1 Introduction

This document describes the PHY enhancements to enable the space-time processing (STP) functionalities in the optional FUSC [1] and the optional adjacent subcarrier permutation (or AMC) [2] zones for OFDMA. The following features are proposed:

2 Specific Text Changes

8.4.8.3 STP using the optional FUSC and the optional adjacent-subcarrier permutation zones for DL

Figure yyy-1 Pilot allocation method #1

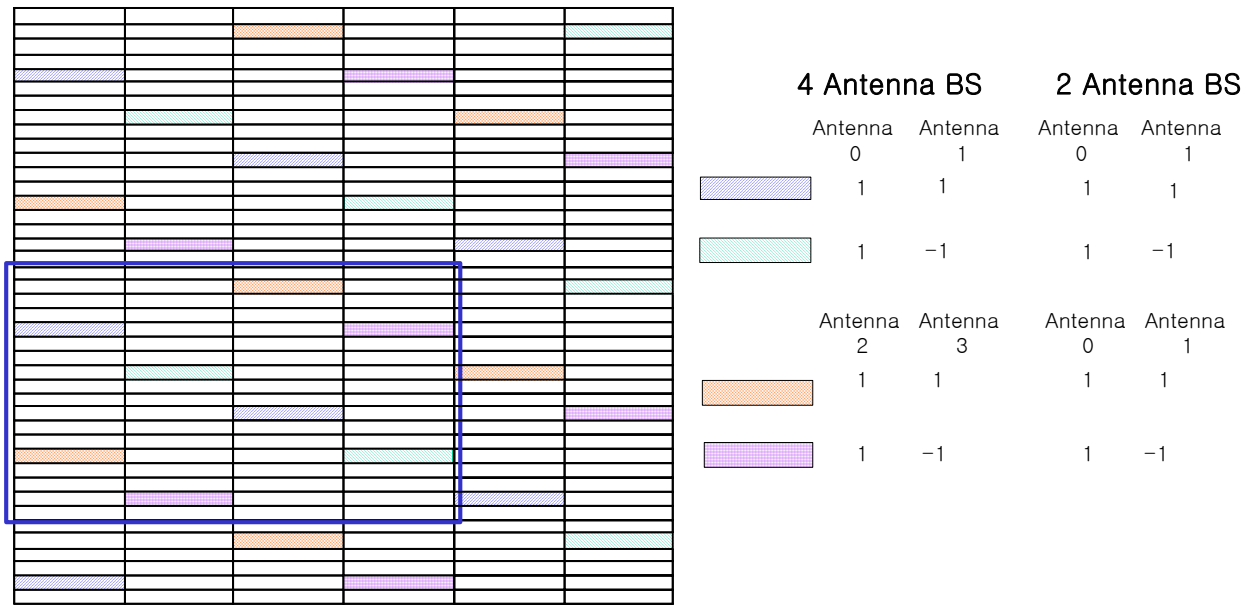
Method 1: use of disjoint pilot sets

Pilots are split into 2 or 4 disjoint sets. For 2-antenna BS, all pilots in the even symbols allocated for Ant 0 whereas all pilots in the odd symbols used for Ant 1. For 4-antenna BS, pilots in the even symbols are further split for Ant 0 and 1, while those in the odd symbols split for Ant 2 and 3. See Figure yyy-1.
